Office Action Summary	Application No. 10/594,916	Applicant(s) YABU ET AL.	
	Examiner JUSTIN LOFFREDO	Art Unit 3744

DETAILED ACTION

Harushige – Figure 1

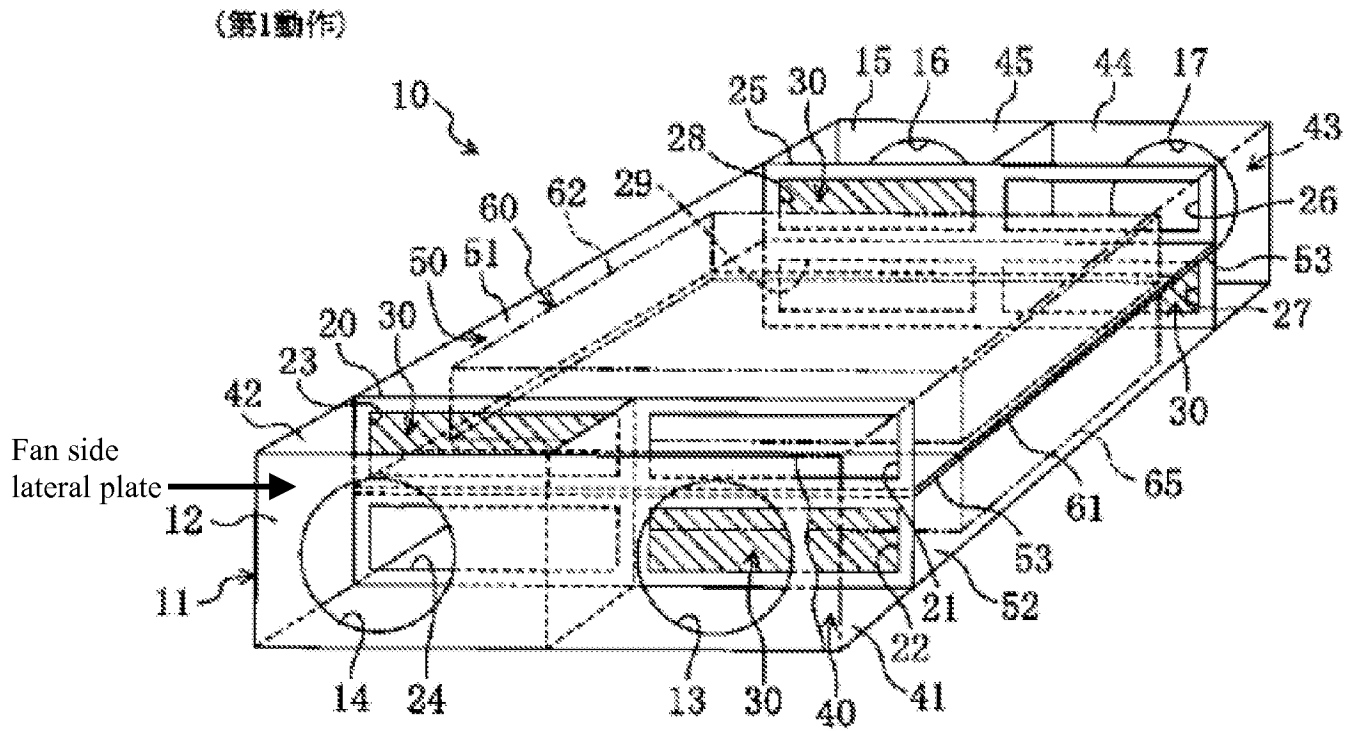
Consider claim 1. Harushige discloses a humidity control system for supplying either one of a dehumidified first air stream and a humidified second air stream to an indoor space and for discharging the other air stream to an outdoor space, wherein: the humidity control system comprises: a refrigerant circuit (70) which includes first and second adsorbent-supported heat exchangers (62) & (65), respectively, which are fluidly connected in the refrigerant circuit (70); a box-shaped casing (11) internally having an air passageway (see Fig. 1) in which the heat exchangers (62) & (65) are disposed; an air supplying fan and an air exhausting fan disposed in the casing (11) (paragraph [0031]); a change mechanism (30) (corresponding to the claimed switching mechanism) capable of changing the distribution route of air in the casing (11) depending on the circulation direction of the refrigerant in the refrigerant circuit (70) so that the first air stream is passed through one of the heat exchangers (62) or (65) that is functioning as an evaporator while the second air stream is passed through the other heat exchanger that is functioning as a condenser; wherein the casing (11) has an internal space divided into a outdoor

side space (40) (corresponding to the claimed first space) defined along a fan side lateral plate as a lateral plate of the casing (11), and a center space (50) and indoor side space (43) (which make up the remaining second space as claimed) (Fig. 1); wherein the air supplying fan and the air exhausting fan are disposed in the first space (40) (paragraph [0031]) and the first and second heat exchangers, (62) and (65), respectively, are disposed in the second space (Fig. 1); and a compressor (71) and a four-way switching valve (73) (corresponding to the claimed reversal mechanism) which are both disposed in the second space of the casing (11) (paragraphs [0007]-[0012] & [0064-0066], Figs. 1, 2, 9a & 9b).

Consider claim 8. Harushige discloses that the casing (11) is shaped like a flattened box; and that the first and second heat exchangers (62) & (65), respectively, are arranged so as to allow the passage of air in a horizontal direction of the casing (11) (Figs. 1 & 2).

Consider claim 16. Harushige discloses first (62) and second (65) heat exchangers as previously discussed having outside-air inflow surfaces (Fig. 1).

Consider claim 19. Harushige discloses that in the casing (11) the first and second heat exchangers (62) & (65), respectively, are disposed adjacently to each other and the inflow surface of the first heat exchanger (62) and the inflow surface of the second heat exchanger (65) lie on the same plane (Figs. 1 & 2).

12. In response to applicants argument (Remarks, p. 12) regarding examiner's objection to the drawings that the switching element recited in claim 1 is clearly shown within the drawings and referenced as element (64) (see e.g. Fig. 1), examiner respectfully disagrees. Claim 1 recites "a switching mechanism" as well as "a reversal mechanism". In light of applicant's disclosure, examiner determined that element (64) refers to "a reversal mechanism" as claimed, and since "a switching mechanism" is claimed as a separate element from "a reversal mechanism", reference numeral (64) does not appear to refer to "a switching mechanism" as claimed. Furthermore, applicant discloses (paragraph [0012]) that a switching mechanism is incorporated in order to reverse the direction of *air* flowing through the humidity control system, whereas the reversal mechanism (64) is incorporated in order to reverse the direction of *refrigerant* flowing through the system (see e.g. applicant's disclosure, paragraph [0010]).

14. In response to applicant's argument (Remarks, p. 15) that Harushige's four-way switching valve (73) is simply a valve and does not anticipate an explicit reversal of a refrigerant flow through the refrigerant circuit, the examiner respectfully disagrees. Harushige clearly discloses that switching valve (73) allows the refrigerant flowing through the humidity control system to be selectively reversed depending on system operation (see paragraphs [0069-0074]; Figs. 9a & 9b).
